The City of Spartanburg Design Review Board

AGENDA

October 1st, 2024, at 5:30 P.M.

Site Survey + Building Footprint @ 1" = 20'

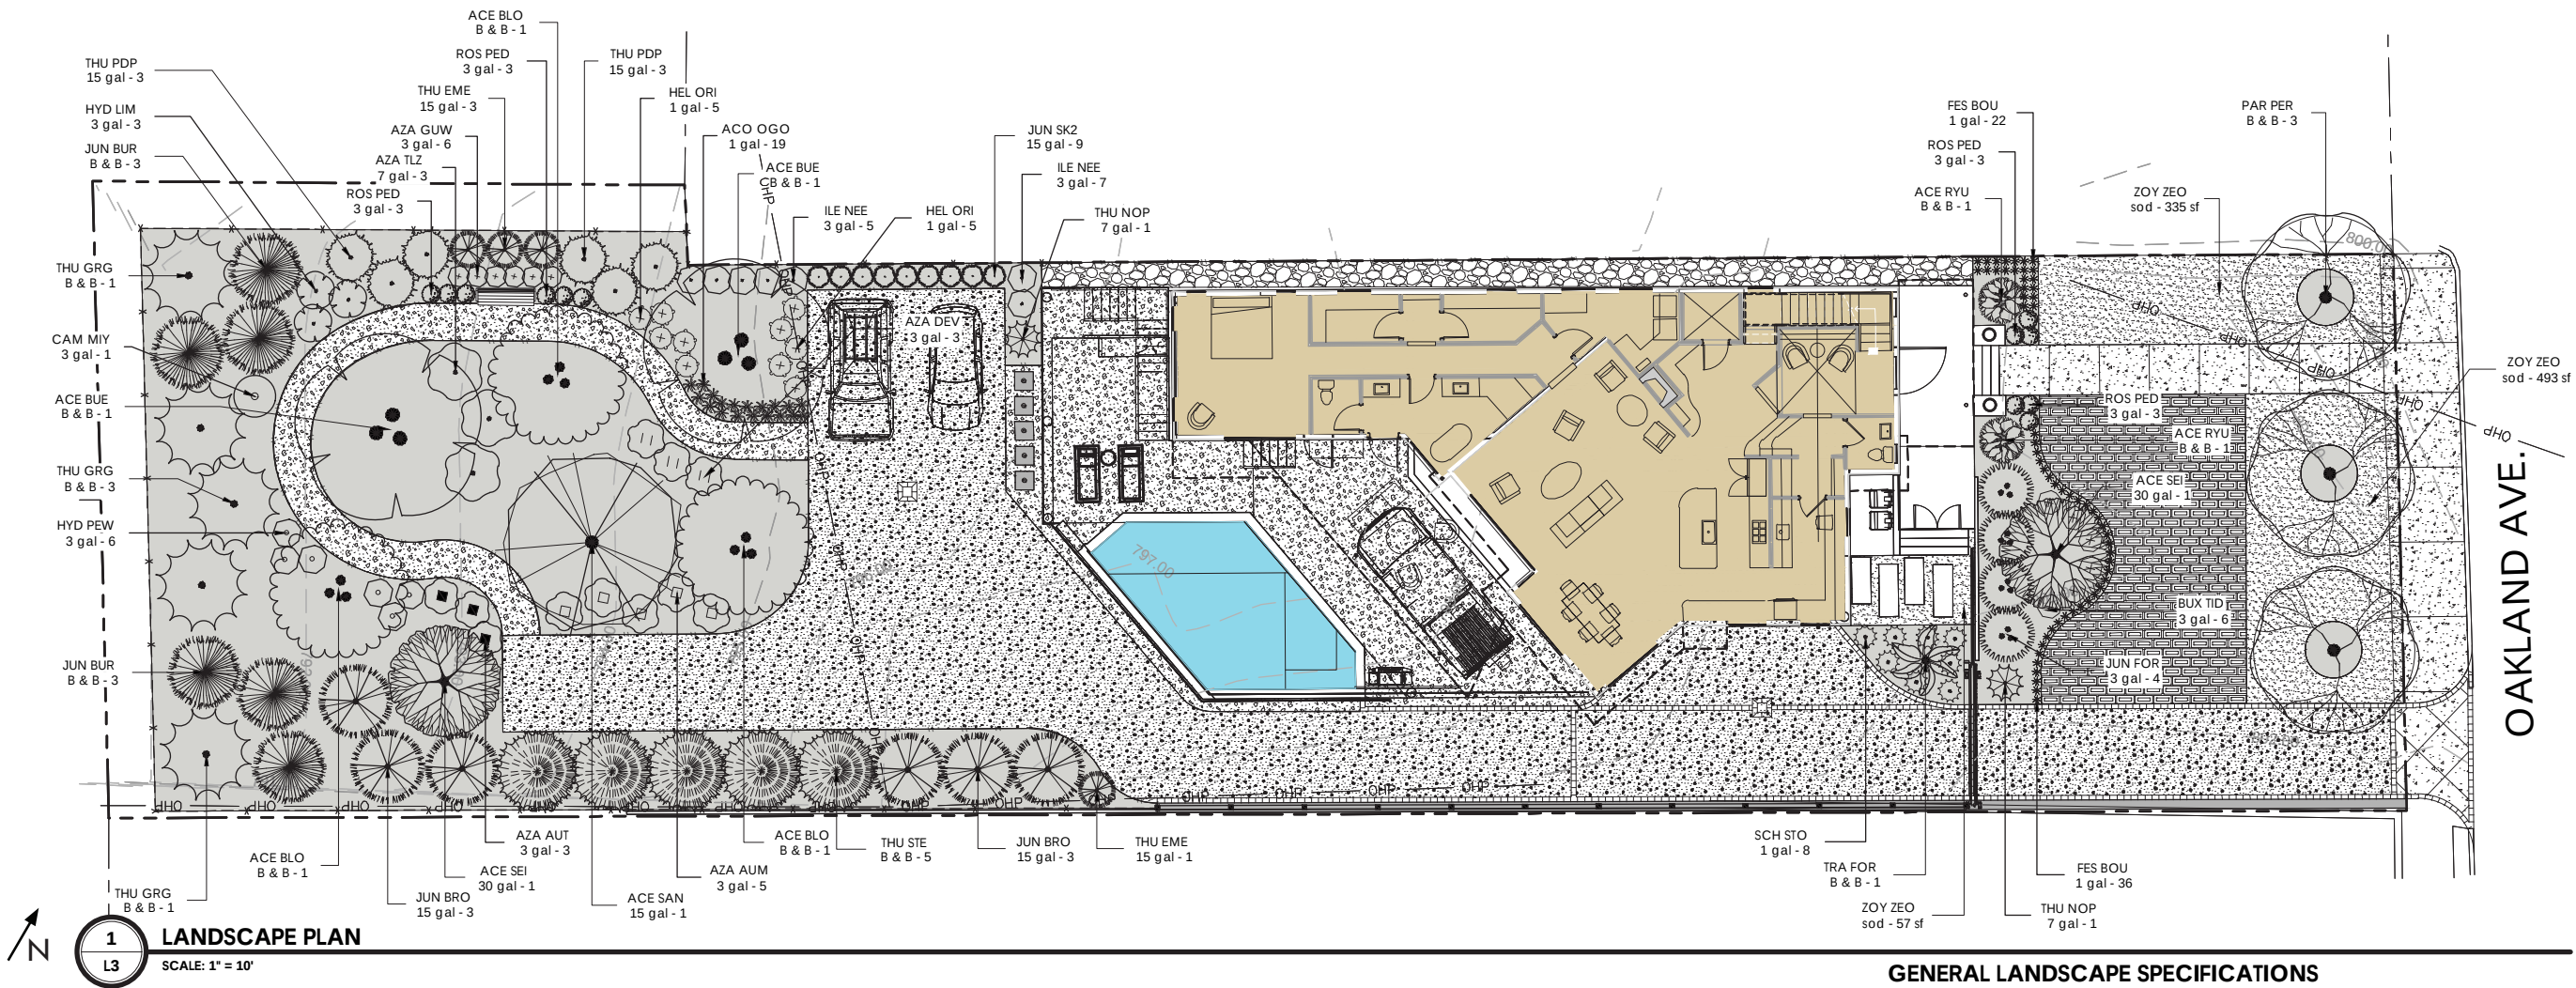
- D-T5: 12 ft/14 ft without tree wells; 8 ft sidewalk; trees in wells –
 - *The existing sidewalk is substandard and crumbling. Please work with the site to provide a solution that provides a minimum 5 foot wide sidewalk prior to Final Approval. – The proposed sidewalk is 7 ft in width.*

SITE + BUILDING FOOTPRINT @ 1/32" = 1'-0"

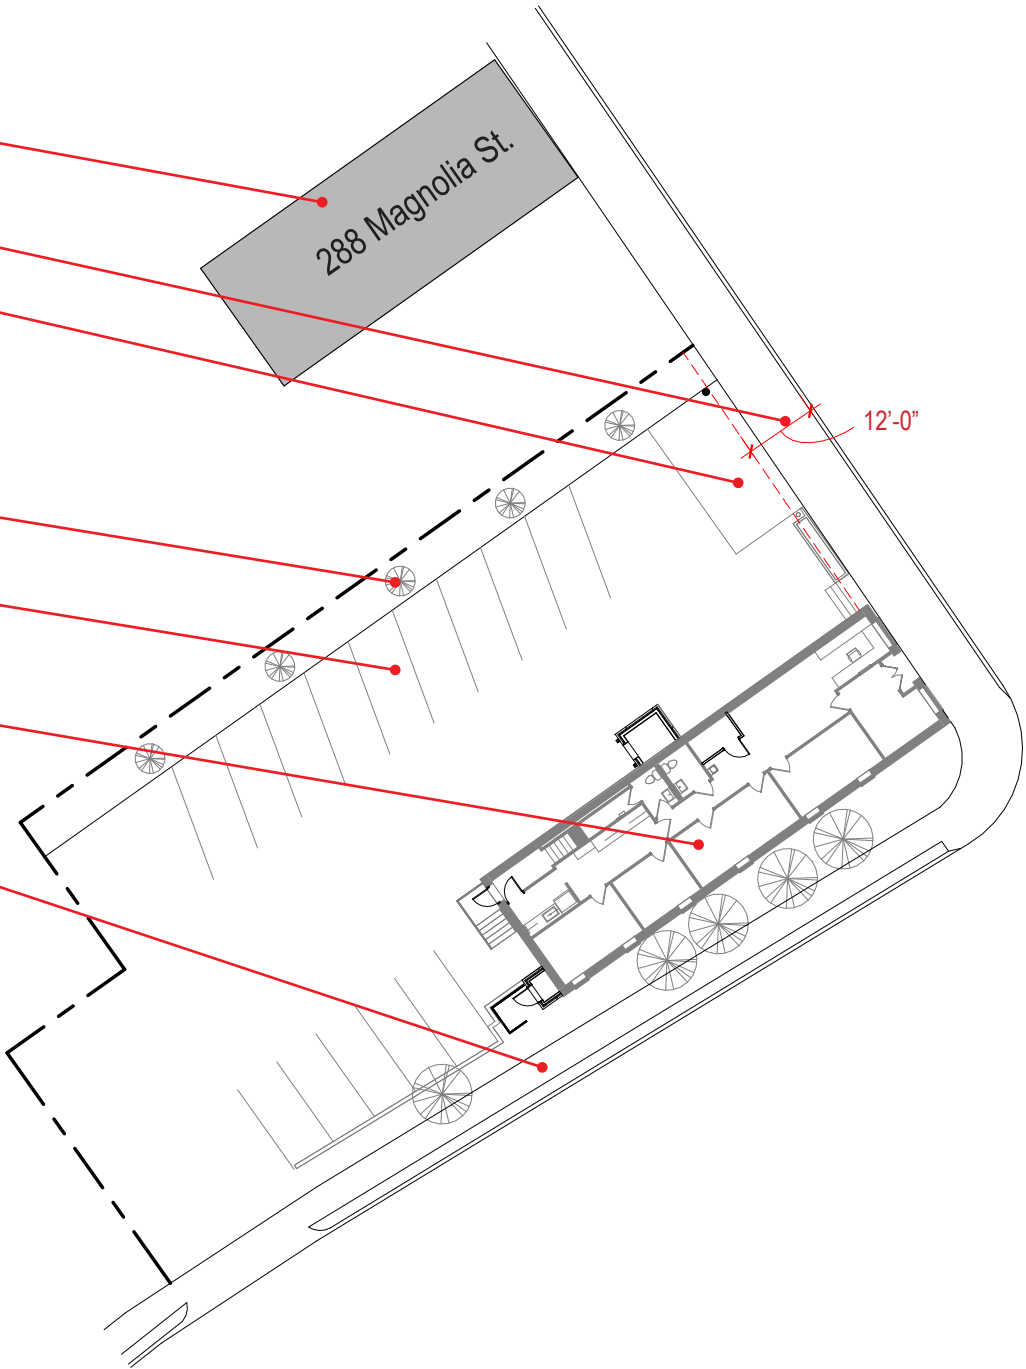
- 7.2 Bicycle Parking: A minimum of 2 bicycle parking spaces shall be provided. *Bicycle parking is not shown on the submitted plans. Please provide.*

- 8.1 Required Streetscape: 12 ft streetscape zone with a minimum 8 ft sidewalk and trees planted in wells consistent with downtown standards (40 ft on-center) – Not Applicable due to the placement of the building and the existing sidewalk.
- 8.2 Site Landscaping: 1 shade tree and eight shrubs per 10 parking spaces. No parking space shall be further than 60 from a canopy tree. *Please note compliance for Final Approval.*

EXISTING FRONT ELEVATION

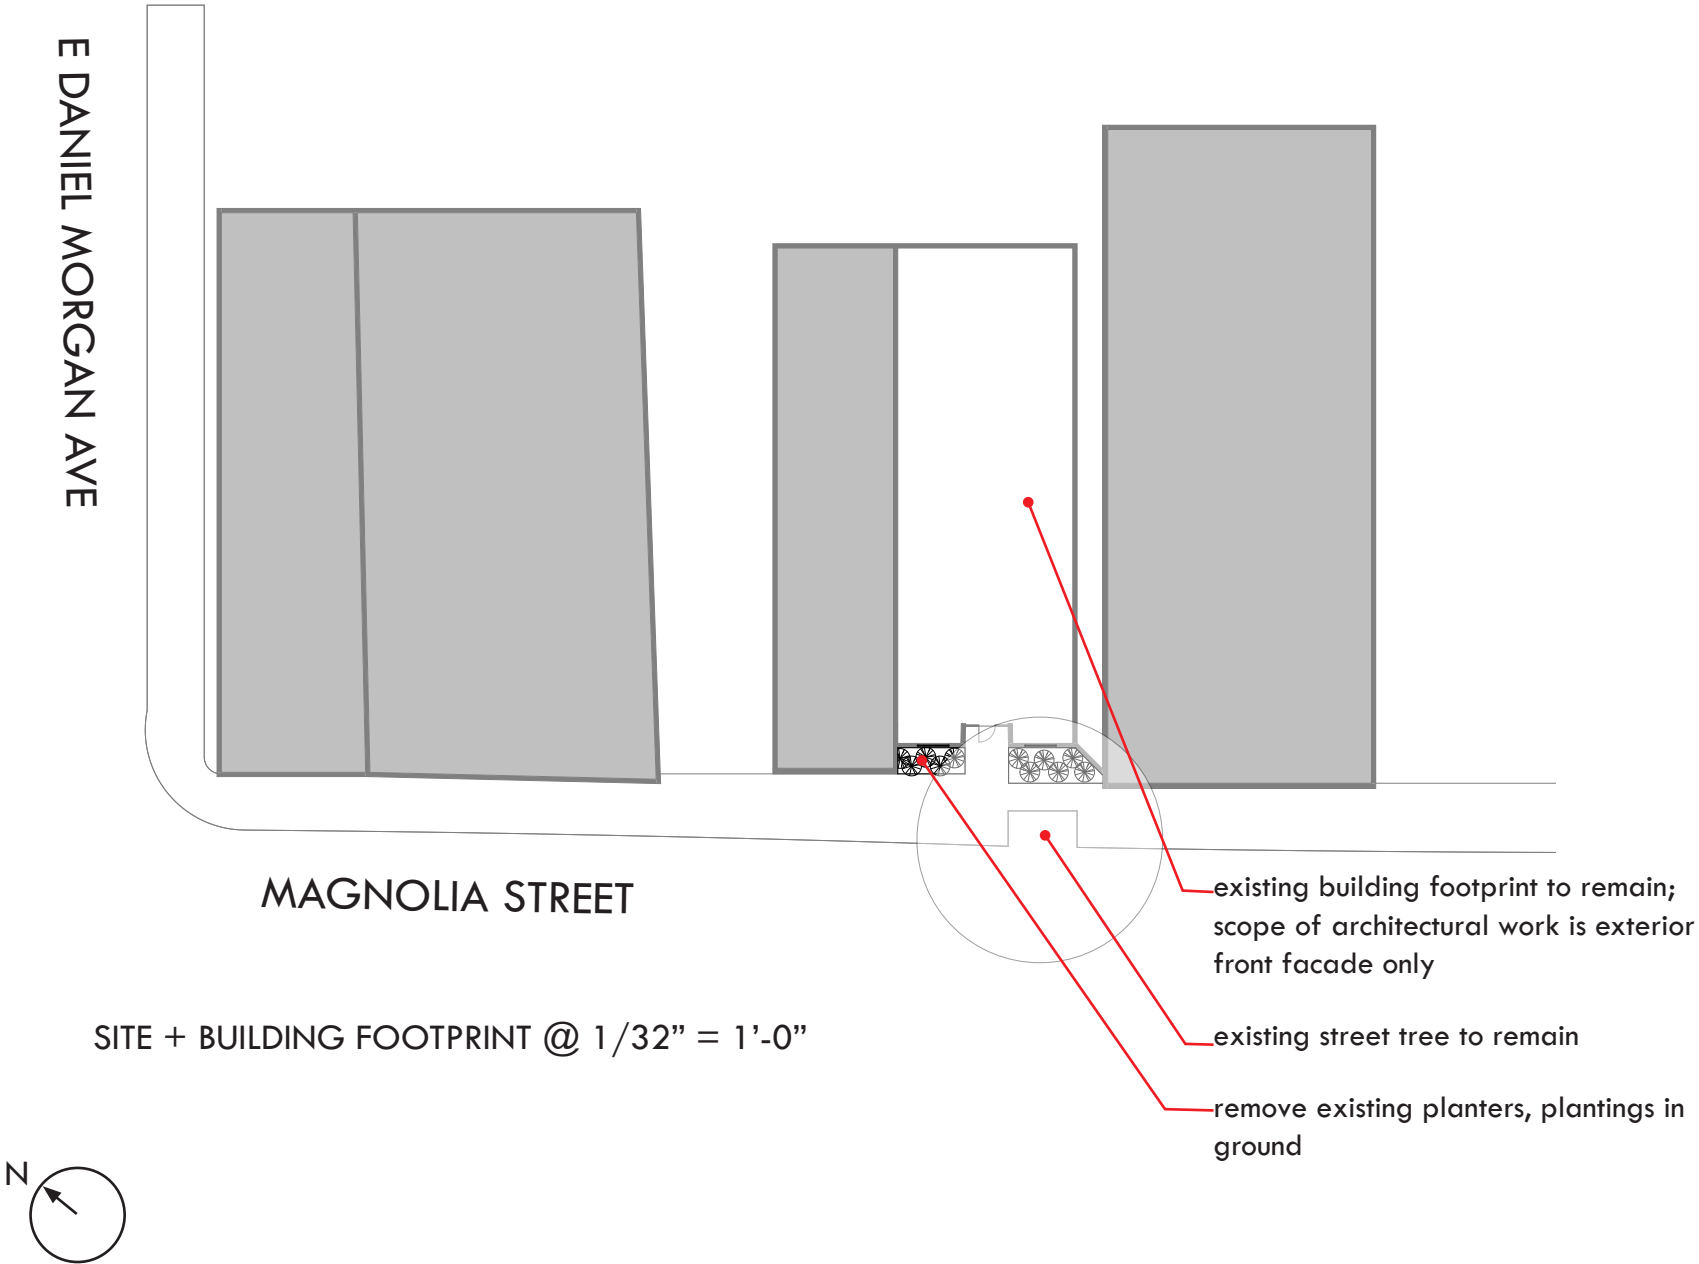
- **Brick Painting:** The existing buff-colored brick and its unique, non-offset coursing is a common detail for mid-century modern buildings. The style itself is one that is intended to reflect the authenticity of the materials and to evoke a more horizontal feel to the façade. In addition, because brick is itself a porous material, painting it, according to the Brick Association, creates a barrier that can trap moisture inside. For most structures, painted brick requires more frequent maintenance and for some structures, painting it can cause mold and mildew growth on the interior and exterior.

- [Staff suggests removing the existing shrubs and installing pavers between the existing sidewalk area and the building. Facing-left, the use of oversize planters with annuals and perennials to add seasonal color is recommended. Facing-right, it is recommended maintaining a more open area to provide a wider pedestrian passageway and further enhance the building entrance.](#)
